**Re: Defect Information Report – Supplemental Report No. 11
10V-177 School Bus, 10V178 Non School Bus, FL-577
Hydraulic Brake Switches – Revised Dealer Bulletin**

FL577A-D

THIRD REVISED NOTICE

Subject: Hydraulic Brake Switches

Fig. 3, Brake Switch Installation (fixed pedal shown)

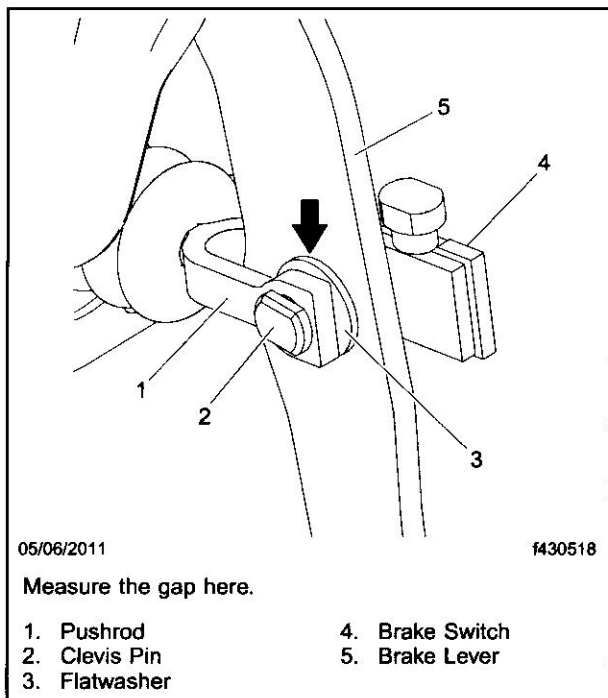
1. Locate the brake switch on the brake pedal. See **Fig. 1** for location on a fixed brake pedal. See **Fig. 2** for the location on an adjustable brake pedal.
2. Cut the tie strap on the harness leads going to the brake switch, and unplug the switch.
3. Remove the cotter pin, flatwashers, clevis pin, and brake switch and discard all of these parts.
4. Install the new clevis pin, flatwashers, brake switch, and hitch pin from the kit. Make certain one flatwasher is between the pushrod and the brake lever as shown in **Fig. 3**.

5. Using a feeler gauge, measure the space between the flatwasher and the brake pedal as shown in Fig. 3.
If the gap is *less than 1.2 mm*, replace the brake pedal. Go to "Hydraulic Brake Pedal Replacement" in these Work Instructions.
If the gap is *1.2 mm or more*, no further work is needed.
6. Attach the new harness pigtail to the existing harness and the newly installed brake switch. Use tie straps to secure excess wiring away from the throttle pedal.
7. Check for proper brake light operation.
8. Clean a spot on the base label (Form WAR259) and attach a completion sticker for FL577 (Form WAR260) to the base label.

Fig. 4, New Brake Switch Installation (fixed pedal)

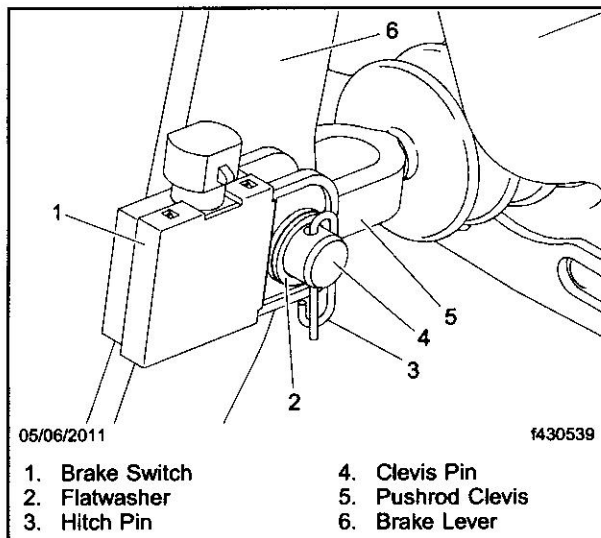
Make certain the other flatwasher is between the brake switch and the hitch pin, and that the hitch pin is installed as shown in **Fig. 4** for fixed brake pedal installations, or **Fig. 5** for adjustable brake pedal installations.

Fig. 6, Removing the Fixed Brake Pedal

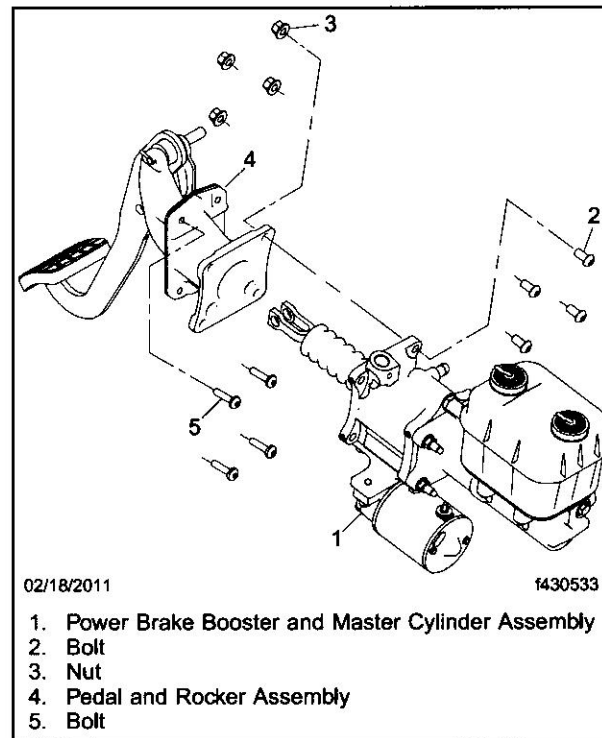
1. Remove the cotter pin from the brake clevis and remove the clevis pin from the brake pedal. See Fig. 6.
2. Disconnect the master cylinder from the brake cylinder and support the master cylinder by zip tying it to the engine. Be careful not to bend the hydraulic hard lines.
3. Remove the bolts holding the brake pedal to the frontwall, then pull the brake pedal through the frontwall.
4. Use the existing bolts and install the new brake pedal. Tighten the bolts 10 to 13 lbf-ft (14 to 18 N-m).
5. Connect the master cylinder to the brake pedal.
6. Go to "Hydraulic Brake Light Switch Replacement" in these Work Instructions.

Fig. 1, Brake Switch Location, Fixed Brake Pedal

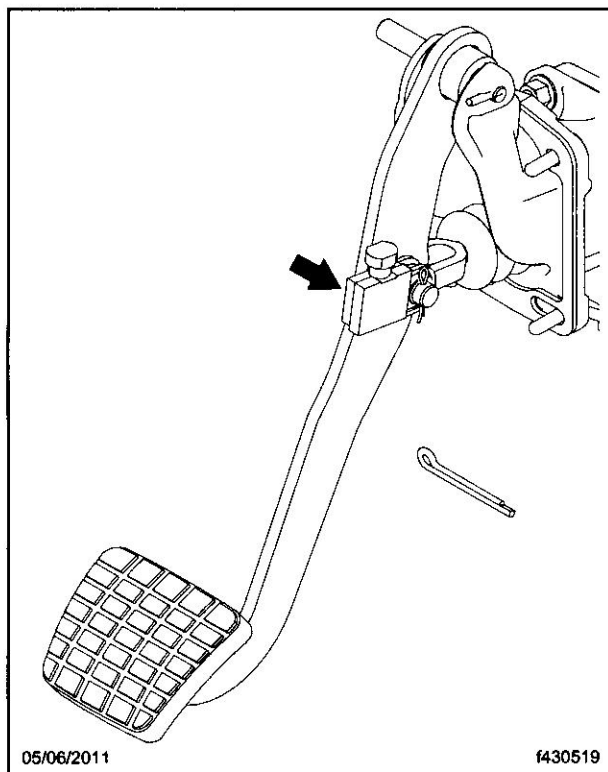
1. Check the base label (Form WAR259) for a completion sticker for FL577 (Form WAR260) indicating this work has been done. On trucks, the base label is usually located on the passenger-side door, about 12 inches (30 cm) below the door latch. On school buses and shuttle buses, the base label is usually located over the driver's window. On motorhomes, the base label is usually located on the front wall, under the dash. If a completion sticker is present, no further work is needed. If a completion sticker is not present, continue with the next step.
2. Park the vehicle on a level surface, shut down the engine, apply the parking brake, and chock the tires.
3. Determine whether the brake pedal is fixed or adjustable. See **Fig. 1** and **Fig. 2**.
